Title of Change:	Revision of Case Outline 846A-02.
Effective date:	12 Aug 2020
Contact information:	Contact your local ON Semiconductor Sales Office or CheePan.Foo@onsemi.com
Type of notification:	This Product Bulletin is for notification purposes only. ON Semiconductor will proceed with implementation of this change upon publication of this Product Bulletin.
Change Category:	New Revision of Case Outline 846A-02
Change Sub-Category(s):	Datasheet/Product Doc change

**Micro8™
CASE 846A-02
ISSUE J**

In the new rev K update:

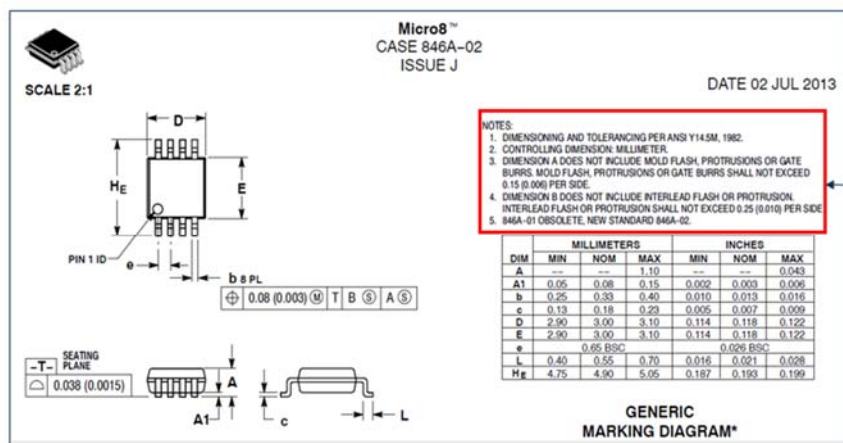
Notes #3 and #4 in the 846A-02 case outline drawing spec 98ASB14087C rev J refer to the wrong dimension A (package height from top package to lead tip) and B (lead width) as the package body outline (correct dimensions should be D and E).

1. The dimension A will be changed to D and dimension B will be changed to E in CASE OUTLINE 846A-02 to reflect the correct reference to the package body outline as per note # 4.
2. Additional note on dimension b had been added as per note # 3.
3. Additional note on datum A and B referencing in note # 5.
4. Additional note to describe the dimension A1 had been added in note # 6.

- NOTES:**
1. DIMENSIONING AND TOLERANCING PER ASME Y14.5M, 2009.
 2. CONTROLLING DIMENSION: MILLIMETERS
 3. DIMENSION b DOES NOT INCLUDE DAMBAR PROTRUSION. ALLOWABLE PROTRUSION SHALL BE 0.10 mm IN EXCESS OF MAXIMUM MATERIAL CONDITION.
 4. DIMENSIONS D AND E DO NOT INCLUDE MOLD FLASH, PROTRUSION OR GATE BURRS. MOLD FLASH, PROTRUSIONS, OR GATE BURRS SHALL NOT EXCEED 0.15 mm PER SIDE. DIMENSION E DOES NOT INCLUDE INTERLEAD FLASH OR PROTRUSION. INTERLEAD FLASH OR PROTRUSION SHALL NOT EXCEED 0.25 mm PER SIDE. DIMENSIONS D AND E ARE DETERMINED AT DATUM F.
 5. DATUMS A AND B ARE TO BE DETERMINED AT DATUM F.
 6. A1 IS DEFINED AS THE VERTICAL DISTANCE FROM THE SEATING PLANE TO THE LOWEST POINT ON THE PACKAGE BODY.
